LEGEND (ALL CHANGES TO ALL LEVELS)

Elevation 1

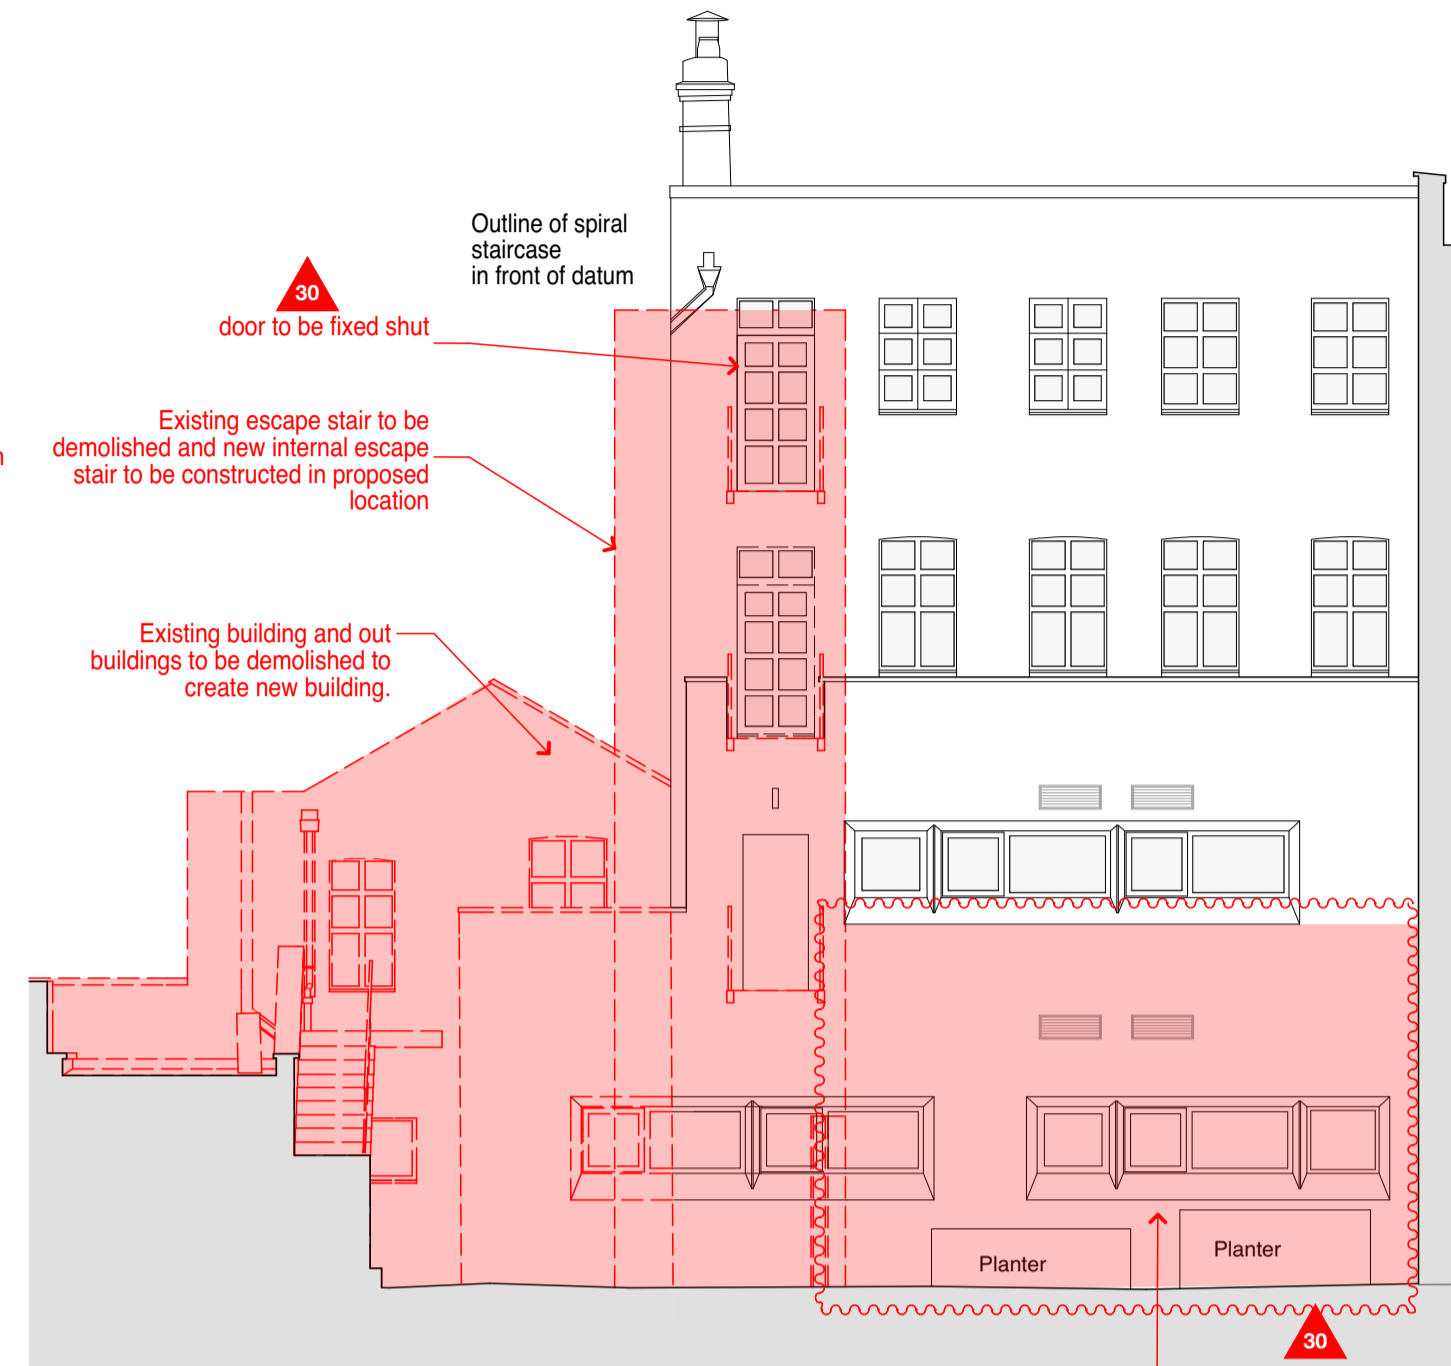
- ▲1 Stair 2 omitted, and glazed entrance enclosure enlarged
- ▲2 Window added
- ▲3 New steps to base of external spiral stair
- ▲4 Stair 3 roof and gable end arrangement revised.

- ▲5 Level 3 accommodation mansarded
- ▲6 Roof light size, height and position adjusted, and smoke vents added.
- ▲7 Louvres omitted.
- ▲8 Roof light size, height and position adjusted.

- ▲9 External ramp adjusted, and railings added.
- ▲10 West stair core glazing fenestration adjusted to suit amended stair landing levels.
- ▲11 External paving levels in courtyard raised to achieve required paving falls.

- ▲12 Low brick plinth added to base of external walls to TP2.
- ▲13 Brick plinth added to base of existing buildings within courtyard.
- ▲14 New steps and landing outside room G1.

- ▲15 Bin store enlarged and repositioned.
- ▲16 Gallery passageway to TP2: finishes revised.
- ▲17 Gallery passageway; entrance gates design revised.
- ▲18 Window on north elevation of TP2 reduced in length.

- ▲19 Revised turn-table size and position
- ▲20 Entrance ramp gradient and levels adjusted.
- ▲21 External levels adjusted
- ▲22 TP1 west door ramp omitted

- ▲23 Fall restraint added
- ▲24 Gates removed
- ▲25 Maintenance access door added
- ▲26 Parapet revised
- ▲27 Roof/wall shape adjusted
- ▲28 TP1 reception relocated

- ▲29 Revised door design
- ▲30 Modifications to windows, doors and facades facing into courtyard.
- ▲31 Gate details revised
- ▲32 Revised proposal for bike storage replacing existing bike racks in Dairy shed.

- ▲33 Gate retained and modified
- ▲34 Bike canopy detail revised (typical condition highlighted)
- ▲35 Sub-station doors revised
- ▲36 Steps adjusted
- ▲37 Cladding changed to brass finish

- ▲38 Wall mounted planters revised (typical condition highlighted)
- ▲39 Steel posts added to boundary wall (typical condition highlighted)
- ▲40 Height of glazed entrance roof increased to suit required pitch.

- ▲41 Glazed entrance roof and canopy revised
- ▲42 New roof guarding to existing flat roof
- ▲43 Screening fins and cladding added
- ▲44 Louvres added
- ▲45 Ramp omitted

- ▲46 Door removed and infilled
- ▲47 Access hatch adjusted.
- ▲48 Depth of green/blue roof build-up adjusted.
- ▲49 Blue roof incorporated into green roof and gravel margins added.

- ▲50 Cladding build-up adjusted
- ▲51 Orientation of brass seams adjusted
- ▲52 Roof gutters revised.
- ▲53 Means of escape revisited and exit door added to TP1

- ▲54 Spiral staircase landings added at each floor
- ▲55 Door modified
- ▲56 Basement louvers to external metal staircase landings
- ▲57 Revised proposal for mean of escape in TP1

- ▲58 Revised proposal for window and door
- ▲59 Revised proposal for door to be left as current
- ▲60 Gate to be removed
- ▲61 Capping width adjusted and roof planters shown indicatively.

- ▲62 Door to be replaced
- ▲63 Revised proposal for the entrance
- ▲64 Gates and Entrance door in TP1 to be replaced
- ▲65 Existing stair to be demolished

- ▲66 Existing window and door to be replaced
- ▲67 New reconfiguration for new spiral stair and WC
- ▲68 Staircase partially demolished
- ▲69 Level adjusted

- ▲70 Lift pit adjusted
- ▲71 Level updated
- ▲72 Red line extended to include South Crescent Mews
- ▲73 Red line extended to include new ramp and frontage

- ▲74 Ladder added
- ▲75 Works to Mews paving/kerbs added
- ▲76 Minor adjustment to ridge, and eaves line, (not affecting ridge level noted on consented drawings).
